# **AMD-K6™**

### **Revision Guide**

| Publication # 21266   | Rev: D | Amendment/0 |
| Issue Date: July 1997 |        |             |

Figure 1. AMD-K6™ Processor Assertion of HLDA Due to Simultaneous BOFF#/HOLD Assertion

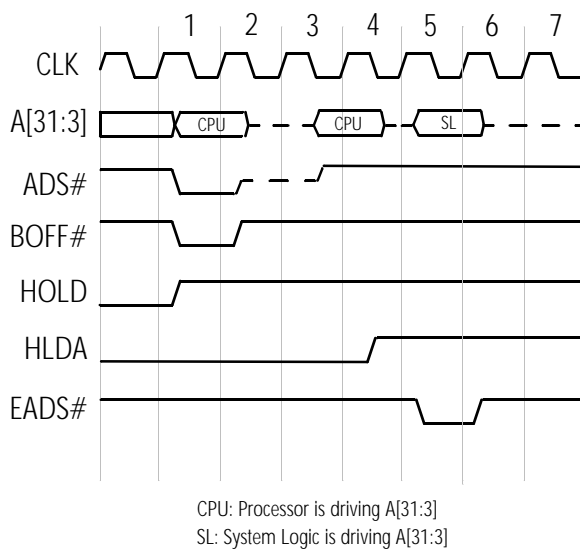
*Non-conformance.* If BOFF# and HOLD are sampled asserted on the same clock edge that negates ADS#, the processor asserts HLDA two clock edges after HOLD is sampled asserted.

- If the system logic asserts BOFF# for a duration of one clock, anticipates the assertion of HLDA in clock 3 (see Figure 1)—which is the normal specified operation—and drives the address bus and EADS# for an inquire cycle in clock 3, then the processor will not sample EADS# asserted. In addition, address bus contention will occur in clock 3.

- If the system logic asserts BOFF# for a duration of two clocks, anticipates the assertion of HLDA in clock 3, and drives the address bus and EADS# for an inquire cycle in clock 3, then the processor will not sample EADS# asserted. (No address bus contention occurs in this case.)

- If the system logic asserts BOFF# for a duration of one clock, anticipates the assertion of HLDA in clock 3, and drives the address bus and EADS# for an inquire cycle in clock 4, then address bus contention may occur in clock 4. (The processor will sample EADS# asserted in this case.)

If the processor does not sample EADS# asserted during an inquire cycle, cache/memory incoherency will occur. Address bus contention can affect the reliability of the processor and the system logic.

*Suggested Workaround.* The system logic must sample the assertion of HLDA before asserting EADS# and driving the address bus for an inquire cycle—as shown in clock 5 of Figure 1.
